UNITED STATES PATENT AND TRADEMARK OFFICE

APPLICATION NO.	FILING DATE	FIRST NAMED INVENTOR	ATTORNEY DOCKET NO.	CONFIRMATION NO.
10/752,936	01/07/2004	James Loyd	930027-2022	5800

Office Action Summary	Application No. 10/752,936	Applicant(s) LOYD ET AL.	
	Examiner Annette F. Dixon	Art Unit 3743

DETAILED ACTION

Fig. 2

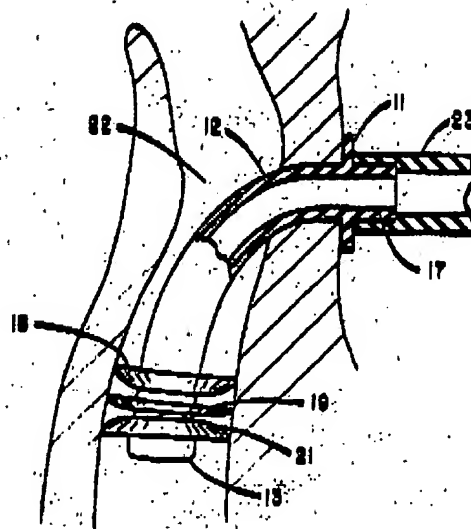
37. **As to Claims 10 and 20**, Bertoch is discussed above, yet fails to teach the first and second flanges being opposedly curved. Miller discloses a tracheal tube seal consisting of "a series of thin, solid, resilient, disc-like flanges (18, 19, and 20) preferably attached to the tubular portion (12) in spaced parallel relationships perpendicular to the axis of the tubular portion" (Please see column 2, lines 13-16). Seen below is Figure 2 of the Miller patent showing the device inserted into the patient.

38. As seen above, the flanges (18 and 21) have become opposedly curved as a result of the flexible nature of the material used to create the flanges and insertion into the patient's trachea. Regarding the middle flange (19), Miller teaches that a choice

when designing the number of flanges that are incorporated into a tracheal device.

(Please see column 2, lines 32-33). It would have been obvious to one having ordinary skill in the art to modify the tracheal system of Bertoch to have provided a dual or multiple flange system for the purpose of creating a tight seal between the tracheal device and the patient's trachea.
